Inspection and/or replacement of the valve push-rod assy., rocker arm left and rocker arm right for ROTAX® Engine Type 912 i, 912 and 914 (Series)

ATA System: 72-30-00 Cylinder head

MANDATORY

SERVICE BULLETIN

Fig. 1
Visual inspection

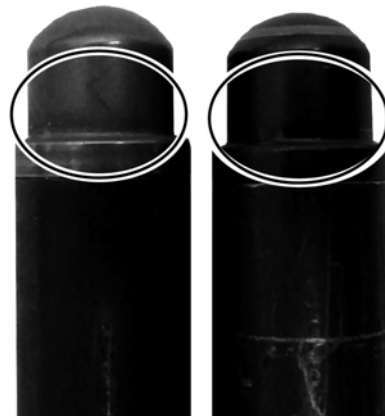
Perform visual inspection of all push-rod ball sockets on all cylinder.
 Check for color. See Fig. 1.

Color	Evaluation
Silver surface	Valve push-rod is OK. No further action required for this valve push-rod.
Black surface	Valve push-rod is NOT OK. See section. 3.1.3) Replacement of affected parts.

Fig. 2

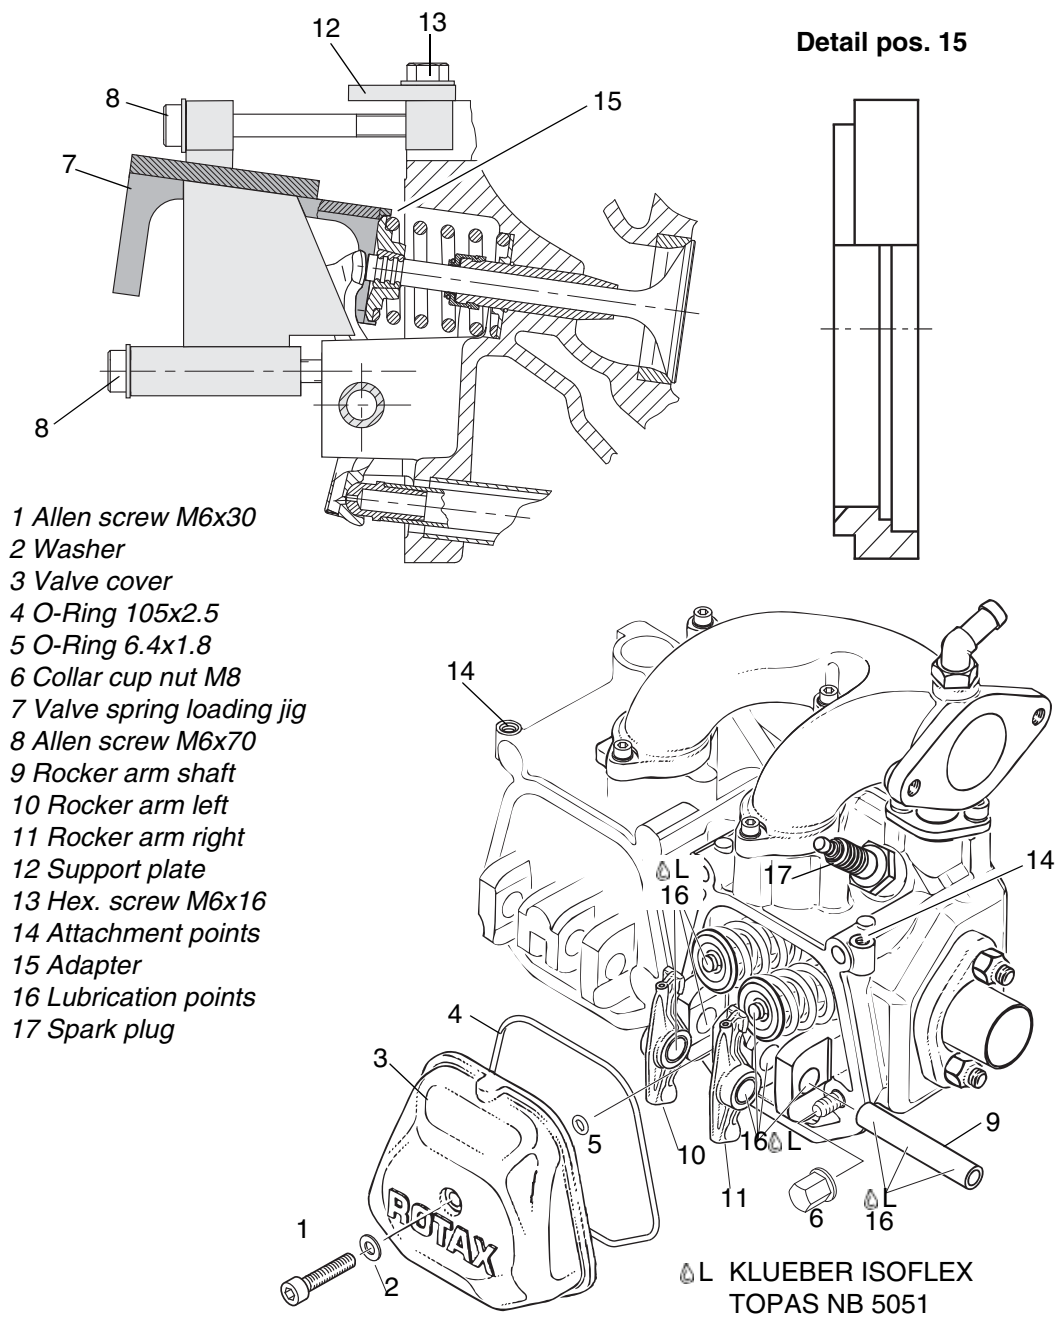
3.1.1) Removing valve covers

See Fig. 2.

Step	Procedure
1	Loosen Allen screw (1) M6x30 with washer (2) from valve cover (3), and remove it together with large and small O-rings (4) and (5).

See [Fig. 2](#) and [Fig. 3](#).

On valve trains with valve push-rods found NOT OK the following steps need to be performed:

Fig. 3

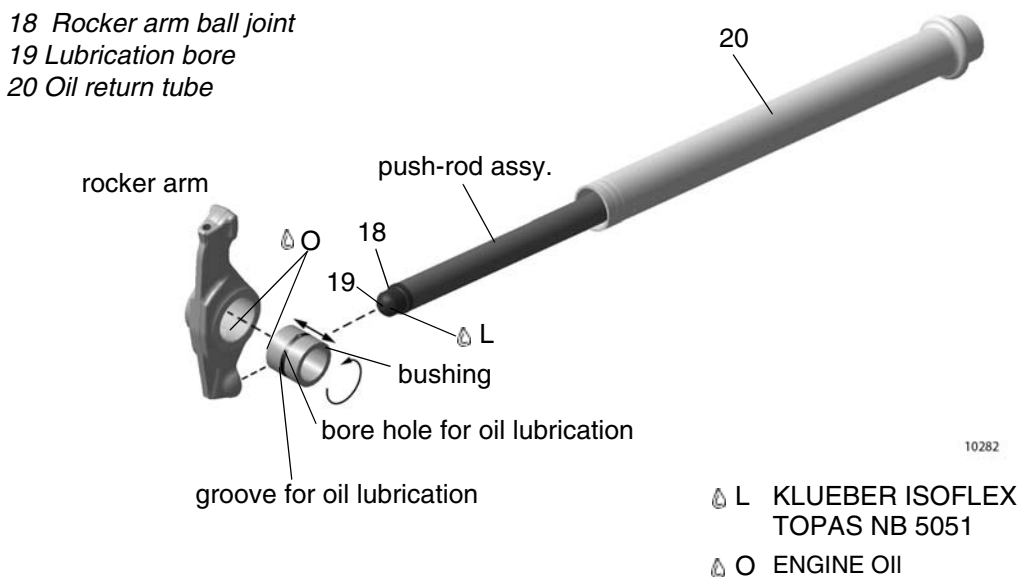
3.1.3) Replacement of affected parts

Step	Procedure
3	Attach the support plate (12) to the valve spring loading jig part no. 877387 (7) with 2 hex. screws (13) M6x16 at the attachment points (14) on the cylinder heads.
4	Put adapters (15) on the valve spring loading jig.
5	Attach the valve spring loading jig on cylinder head and support plate with 2 Allen screws (8) M6x70 and depress both valves with 3 turns.

Step	Procedure
6	This will relieve the pressure from both hydraulic tappets. Now the rocker arm shaft (9) may be easily pulled out. Lift out both rocker arms (10) and (11). NOTE: If you cannot pull out the rocker arm shaft easily, you will need to contact an ROTAX® Authorized Distributor for further action.
7	Replace all affected parts including push rods and rocker arms. See also Fig. 3.
8	Apply KLÜBER ISOFLEX TOPAS NB 5051 (16) on both push-rod ball sockets and contact areas of rocker arm and slide push-rod into the oil return tube (20).
9	Install rocker arm bushing into rocker arm left (10) and rocker arm right (11). Put oil on the rocker arm bushing.
10	Place rocker arm left (10) and rocker arm right (11) in cylinder head, apply KLÜBER ISOFLEX TOPAS NB 5051 (16) on rocker arm shaft (9) and insert it into its bearing support.
11	Loosen valve spring loading jig and support plate.
12	When removing the valve spring loading jig, make sure the adapter rings (15) do not jam on the valve spring retainer.
